Morecambe Offshore Windfarm: Generation Assets

The Applicant's Response to Secretary of State Letter and Request for Information

Document Reference: 10.1

TITLE: Figure 1 Windfarm Site reductions and corresponding area of effect on Liverpool Bay SPA - 30 WTGs

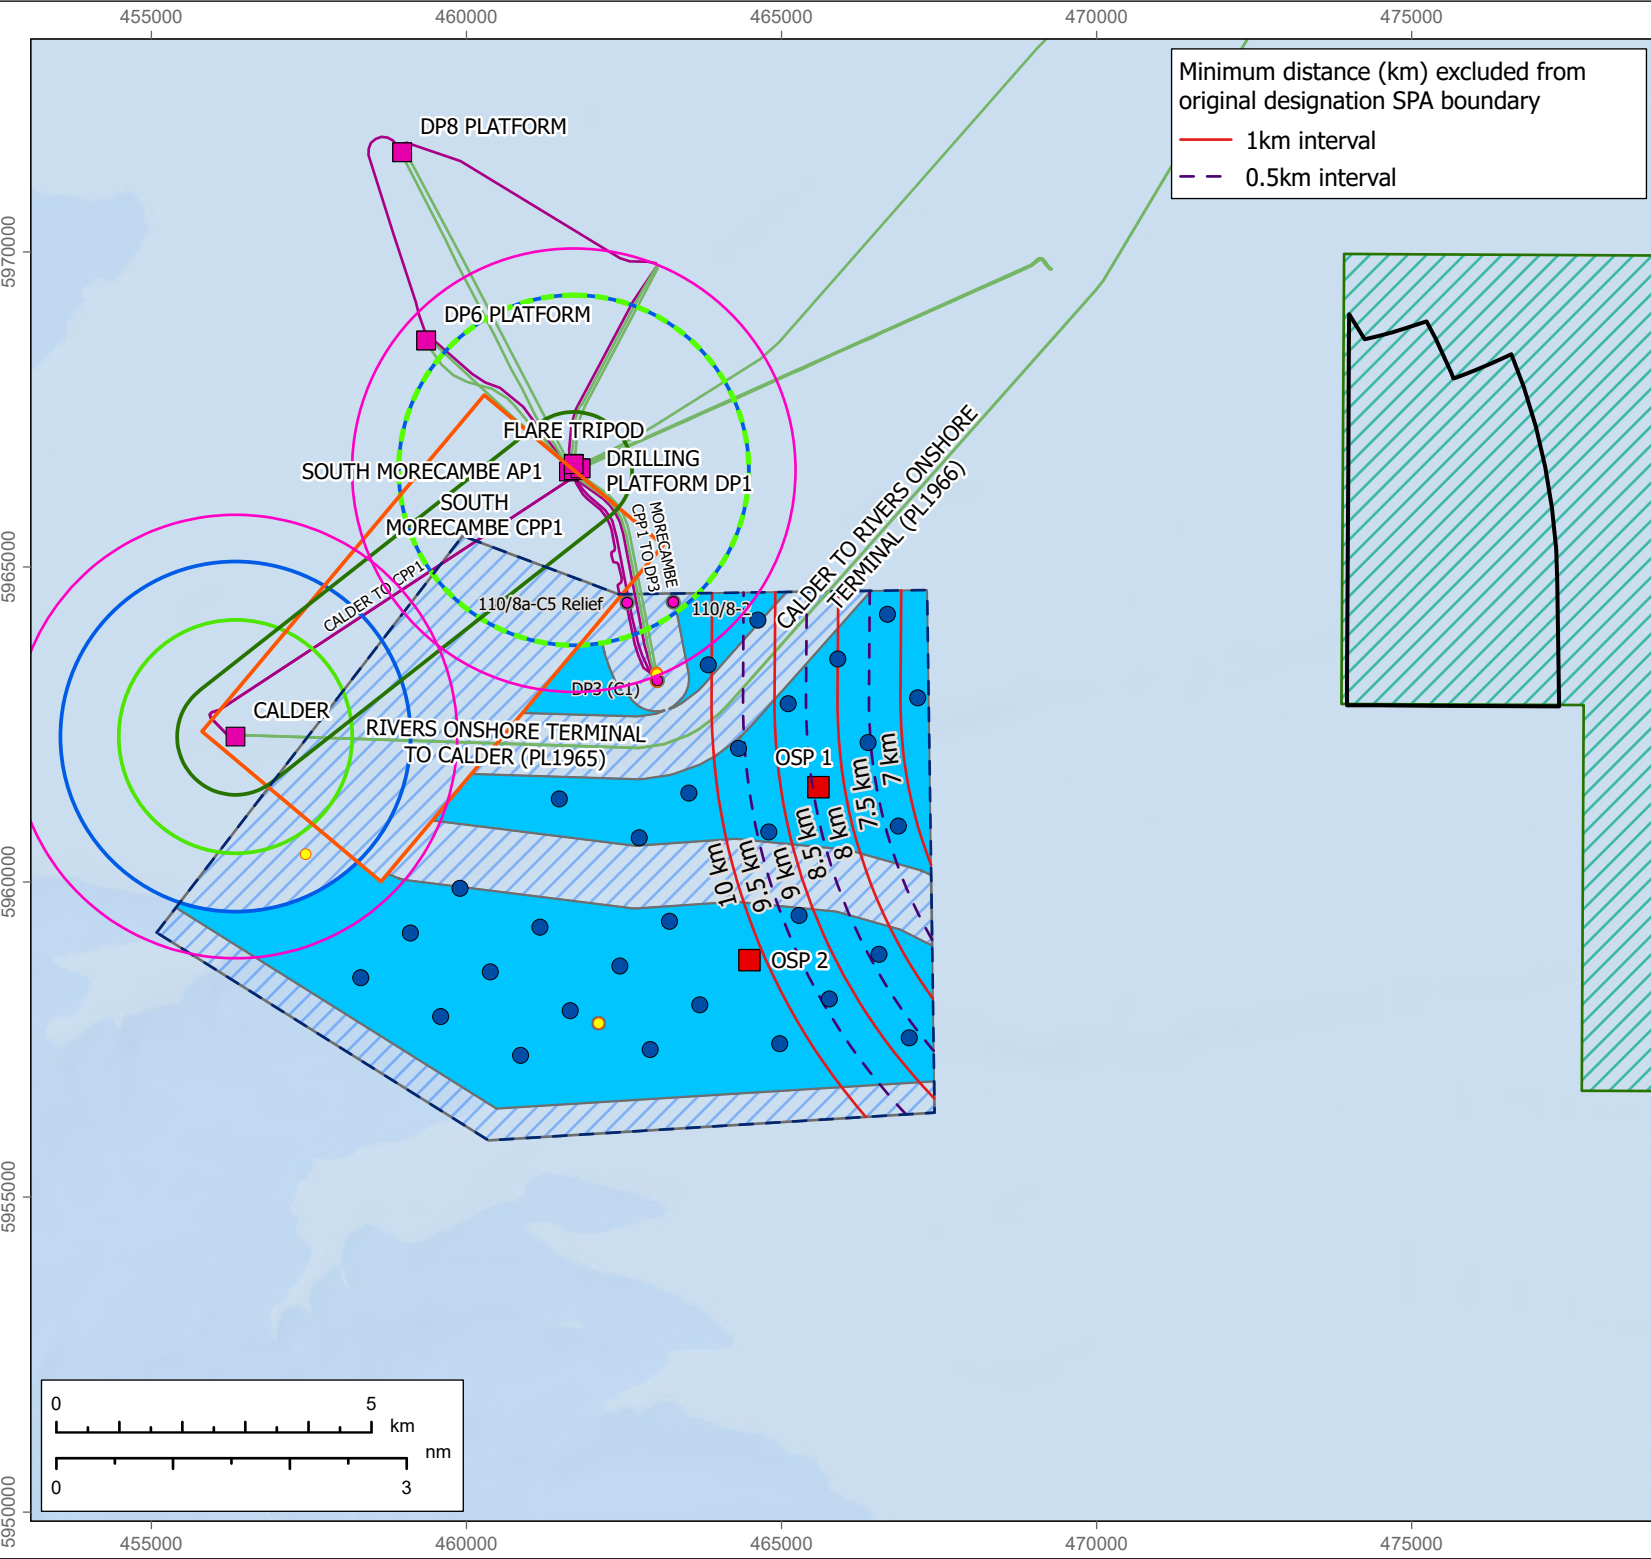
5. *The **Applicant** is requested to provide an updated version of the document titled 'The Applicant's Response to ExA's Written Questions 3GEN2 and 3GEN3' [REP5a-057]. The revised submission should include an explanation of the colour keys used in Figures 2.1 and 2.2 of REP5a-057 or, if the current keys are inaccurate, provide updated versions of these figures with corrected colour keys. Additionally, the Applicant should provide figures with nominal layouts that reflect 1.9nm aviation enduring buffer zones from both the CPC and Calder platforms (as defined in the Applicant's draft DCO [REP6-002]).*

- The colours used to denote the buffers around the original boundary of the Liverpool Bay SPA have been changed for clarity (**Figures 1 and 2**).
- A 1.9nm aviation enduring buffer zone around both the CPC and Calder platforms has been added to all drawings (although note response to Question 20 below and Appendix C containing Protective Provisions agreed with Harbour Energy).

Drawing number	Original Examination Reference	Description of Updates
Figure 1	REP5a-057 Figure 2.1	Colours used for buffers around the SPA boundary revised; addition of 1.9nm buffer around Calder and CPP1
Figure 2	REP5a-057 Figure 2.2	Colours used for buffers around the SPA boundary revised; addition of 1.9nm buffer around Calder and CPP1
Figure 3	New drawing	Drawing based on Figure 1 with current indicative layout for WTGs

TITLE: Figure 3 Windfarm Site reductions and corresponding area of effect on Liverpool Bay SPA – Current indicative layout (34 WTGs)

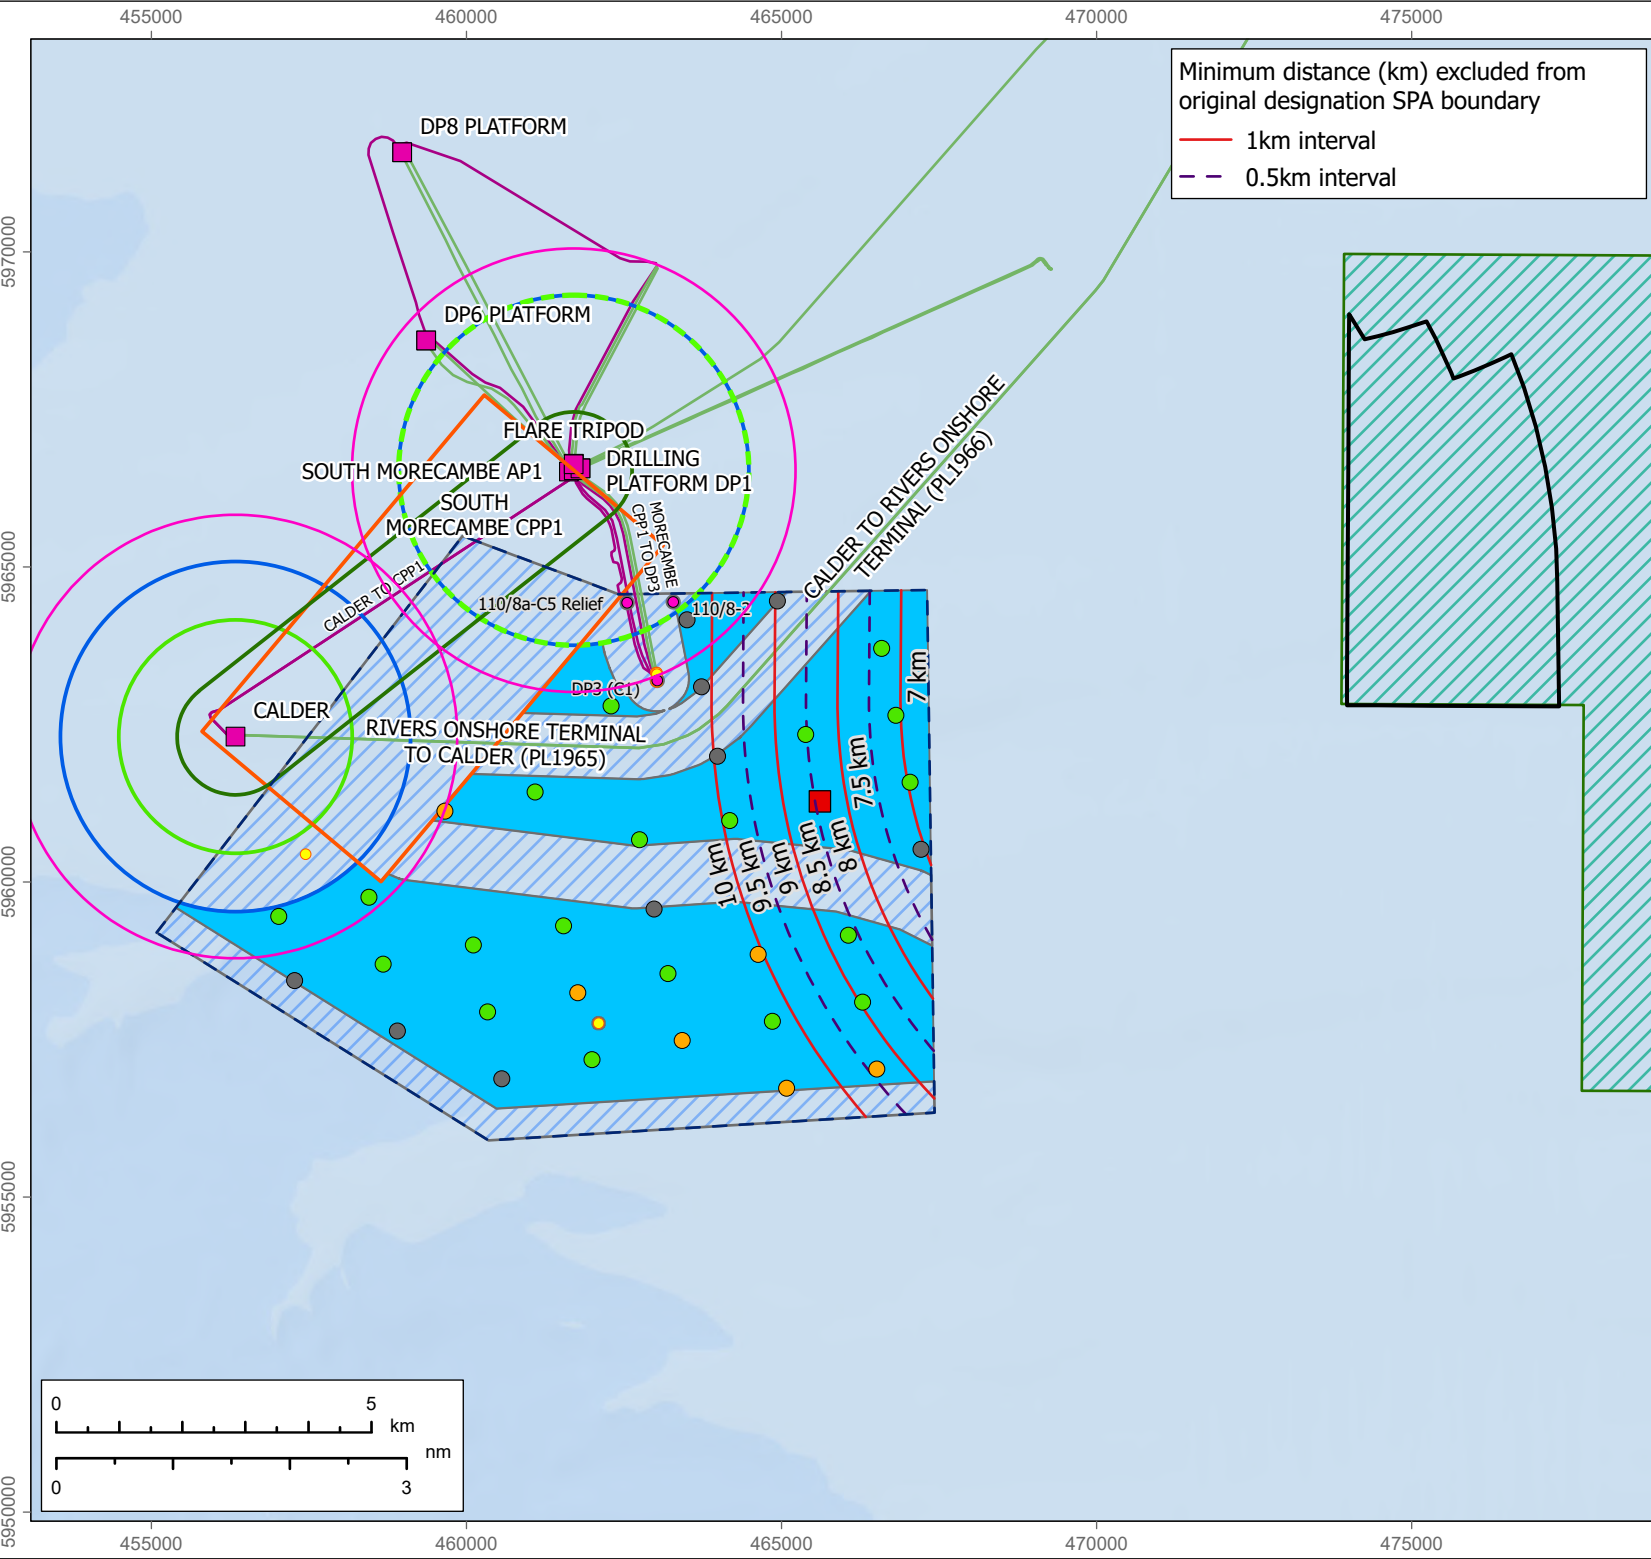
- Two new drawings have been produced (**Figure 3 & Figure 6**); these show the indicative layout for the WTGs at the current stage of the design process, which has developed since the close of the examination. This layout shows 34 locations for WTGs and a substation. Preliminary site investigation work undertaken as part of the Front End Engineering & Design (FEED) process has indicated the presence of potentially challenging ground conditions across parts of the site, which might preclude the preferred installation method (piling) of WTGs in some locations, and these locations are shown in amber. Locations with favourable ground conditions with a high certainty of being able to install WTGs through piling are shown in green. Locations without site investigation data are shown in grey. In total, the current indicative layout shows 19 green locations, 6 amber locations, and 9 grey locations.

32. The additional figures provided in response to Question 5 (**Figure 3** and **Figure 6**) show the indicative layout as at the current stage of the design process. It can be seen that the 34 locations still fill up the site boundary, so it still cannot be concluded with certainty that the turbine locations within the NE proposed buffers will not be needed. As noted in the Applicant's Response to ExA's Written Questions 3GEN2 and 3GEN3 (para. 12 of REP5a-057), the majority of offshore

39. **Figures 3 and 6** show the current indicative layout, which has been developed since the end of the examination as detailed design and engineering work continues. There is a total of four WTG locations within the 7.5km SPA boundary buffer (**Figure 3**), and either one or two locations within the 10km Shell Flat buffer (depending on whether or not the WTG blade tips would be allowed to 'over sail' the buffer) (**Figure 6**). However, based on the indicative layout there are already three turbines located to the west of the site within 1.9nm of the Calder platform, and one to the north of the site within 1.9nm of CPP1. As explained in response to Question 6, losing turbine locations within the proposed Natural England buffers would mean that there are only 30 positions available in total for the installation of turbines and therefore there would not be space for the full maximum design scenario or the full 34 turbine current indicative layout. Even if turbine capacity dictated that only 30 positions were needed then the project would still be at risk because there are no 'spare' locations should additional constraints be identified.
